1. Dee Why RSL Car Wash

PROJECT:
**Dee Why RLS Car Wash
Layout Review**

DRAWING TITLE:
**Proposed Traffic Arrangement and
Layout**

Figure 1 - Proposed Arrangement

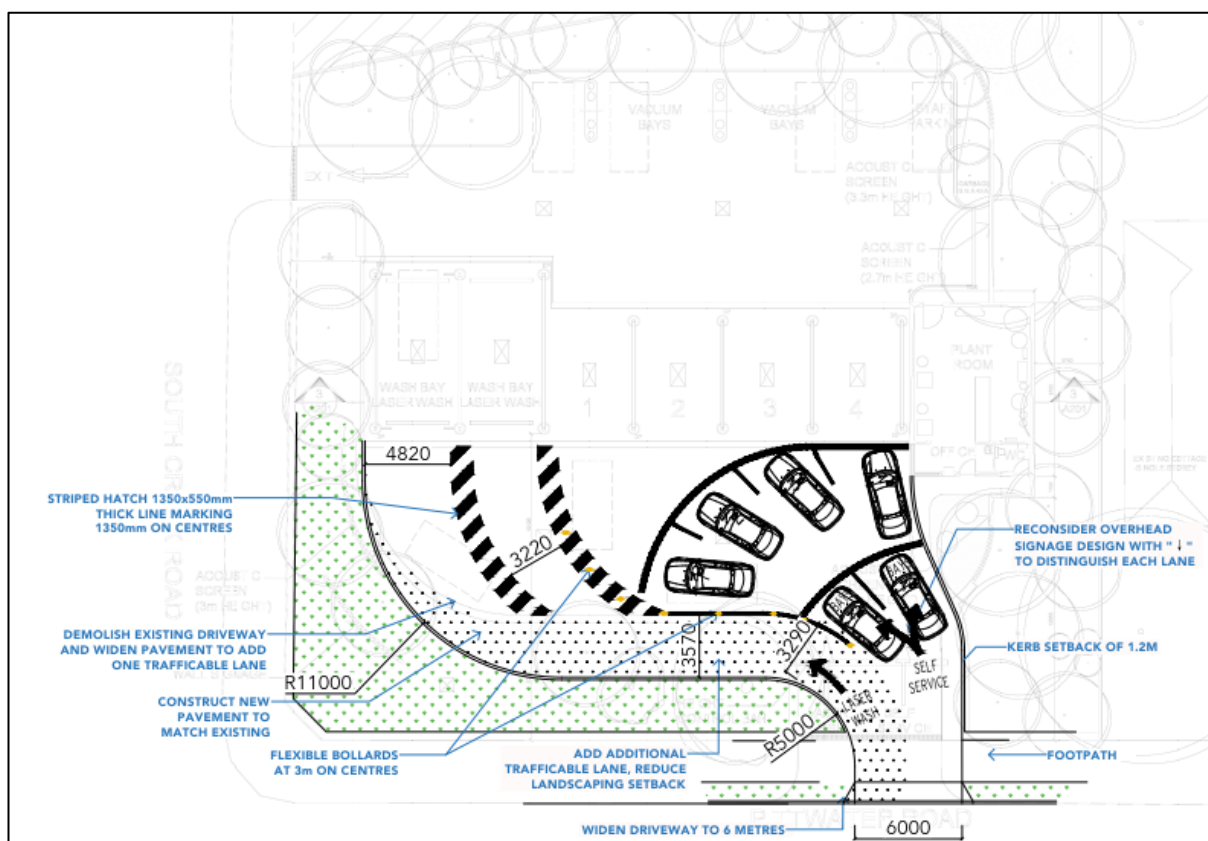
The new arrangement will increase the capacity by approximately 80% - 100% before obstructing internal functions. This will assist in reducing the risk of queueing onto Pittwater Road. Furthermore, this arrangement also represents a first-come-first-serve solution, which will improve customer satisfaction and change the current behaviour of waiting at the driveway.

To achieve this arrangement, the landscaping is to be reduced to allow for a separate lane to be created for auto wash bays 1 and 2 and the driveway will need to be widened to 6m.

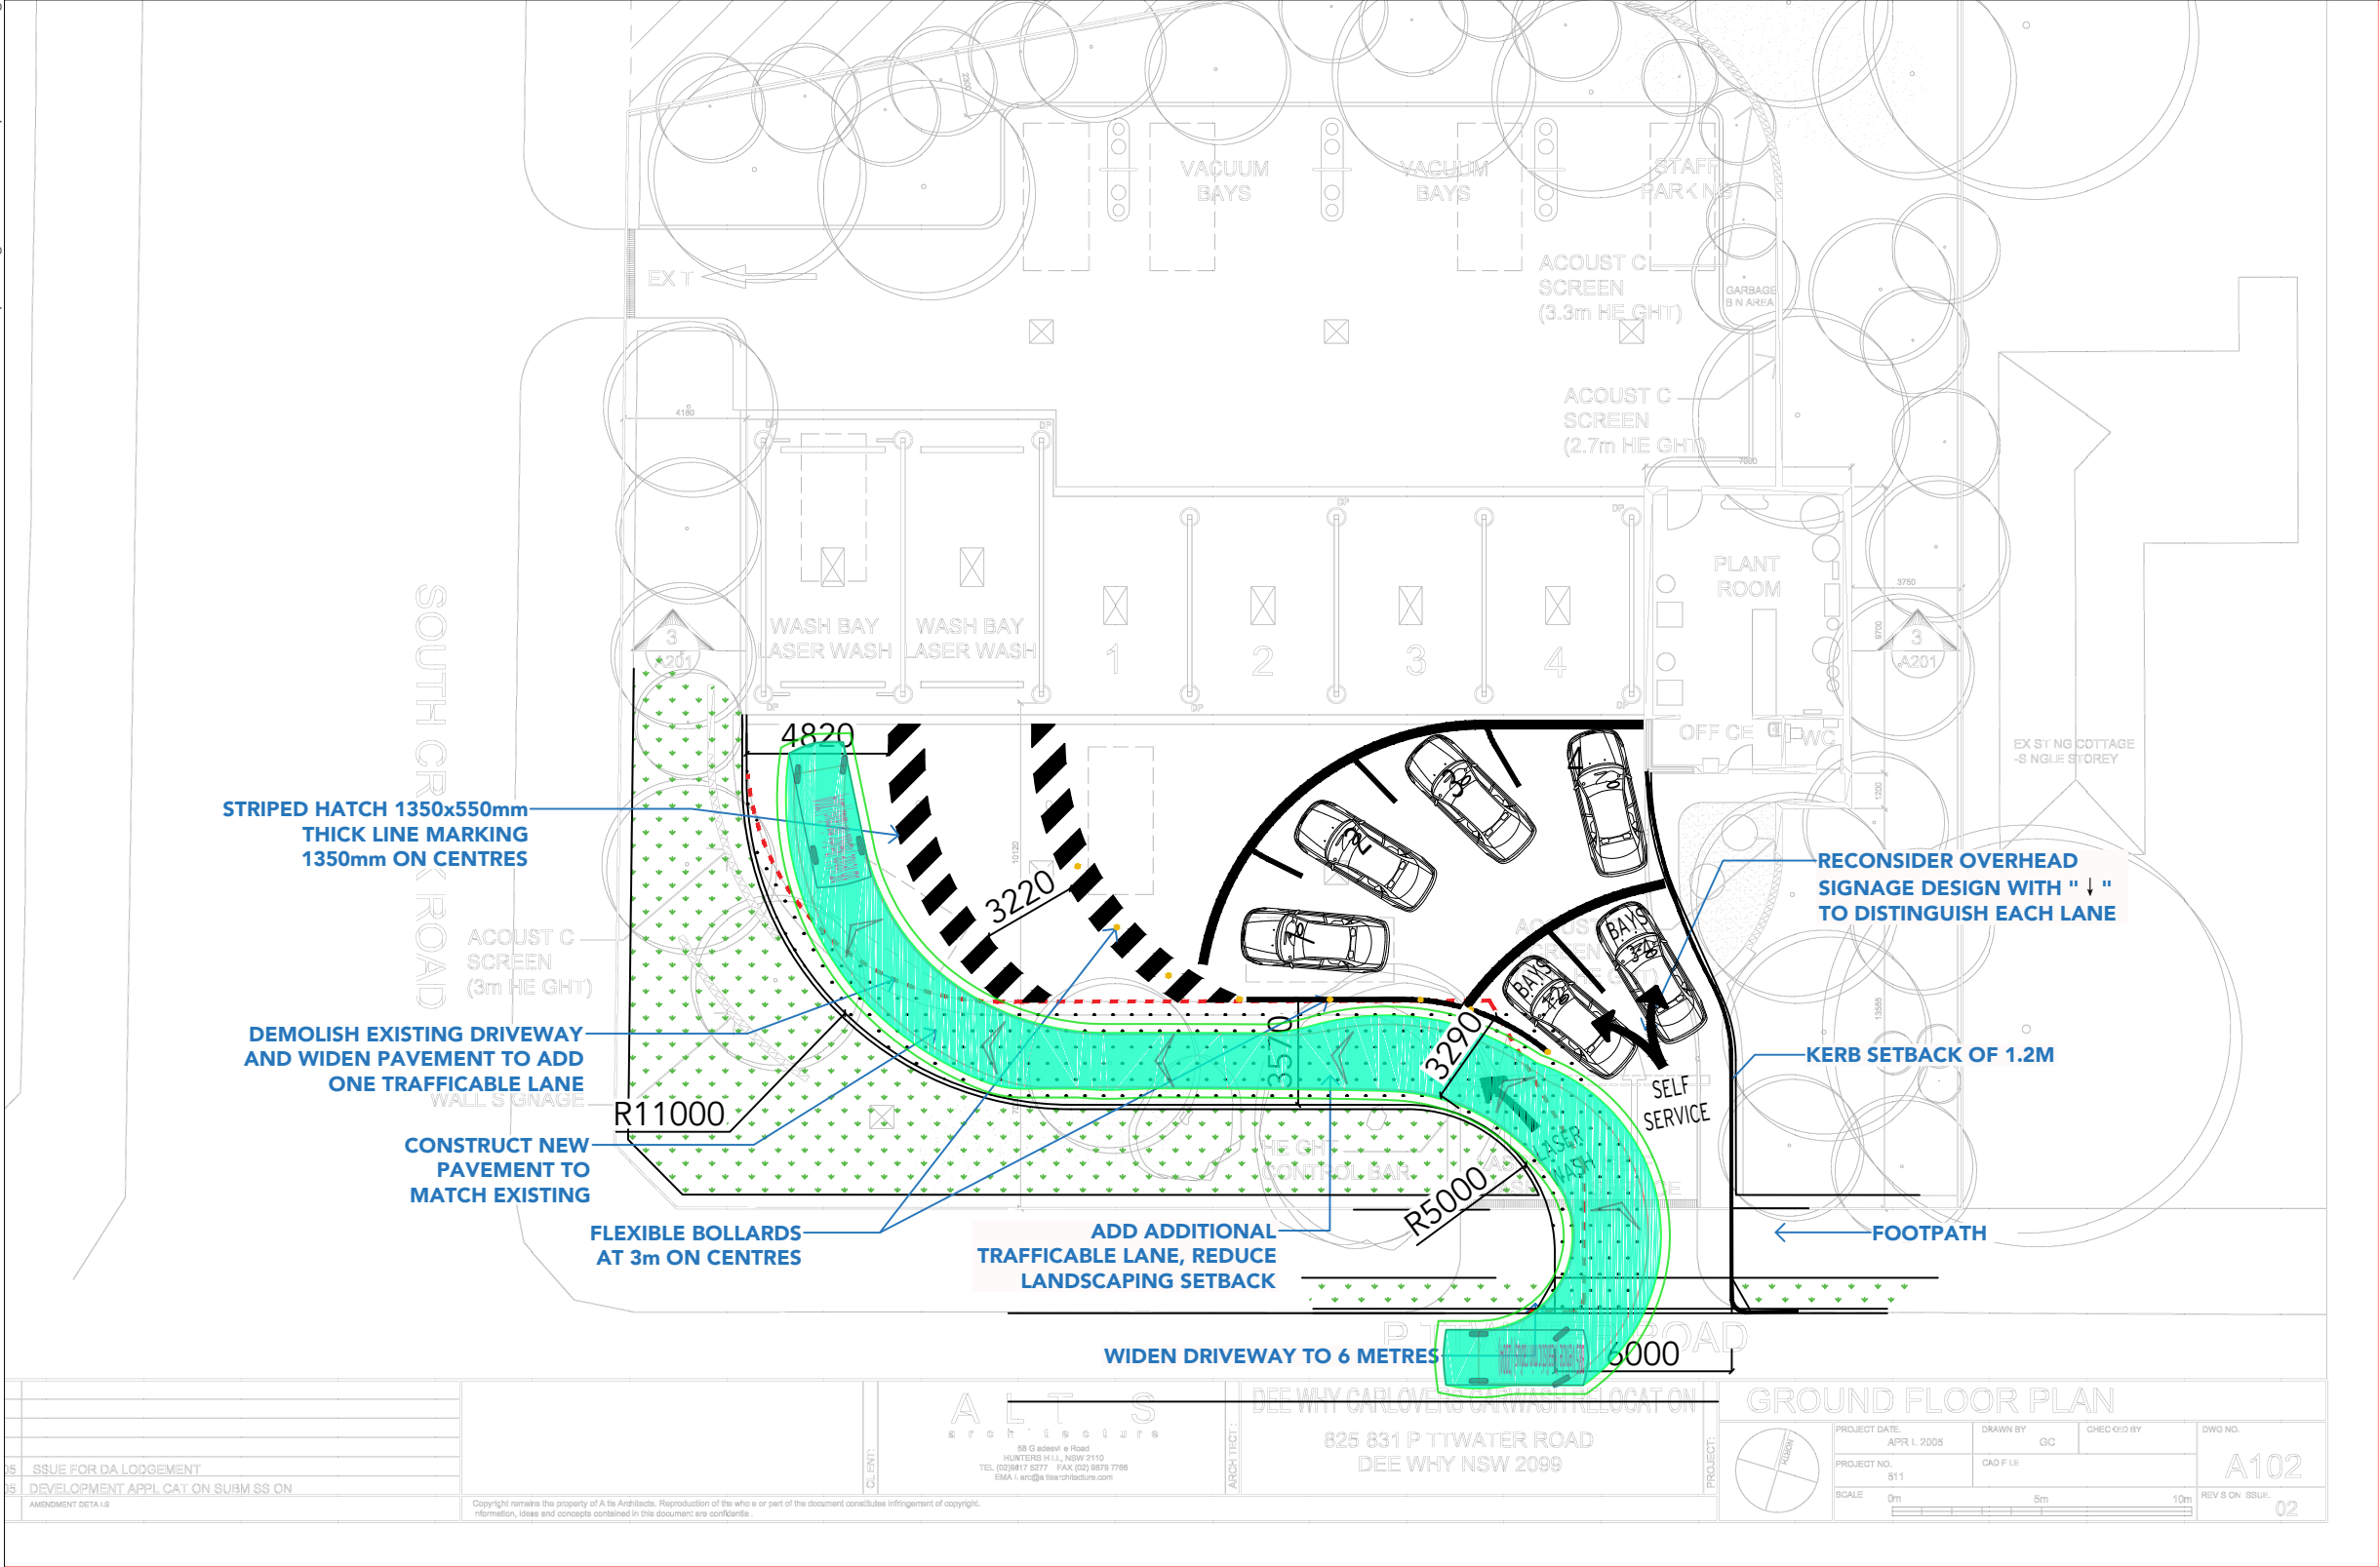
STRIPED HATCH 1350x550mm
THICK LINE MARKING
1350mm ON CENTRES

DEMOLISH EXISTING DRIVEWAY
AND WIDEN PAVEMENT TO ADD
ONE TRAFFICABLE LANE

CONSTRUCT NEW
PAVEMENT TO
MATCH EXISTING

FLEXIBLE BOLLARDS
AT 3m ON CENTRES

ADD ADDITIONAL
TRAFFICABLE LANE, REDUCE
LANDSCAPING SETBACK

WIDEN DRIVEWAY TO 6 METRES

RECONSIDER OVERHEAD
SIGNAGE DESIGN WITH " ↓ " TO
DISTINGUISH EACH LANE

KERB SETBACK OF 1.2M
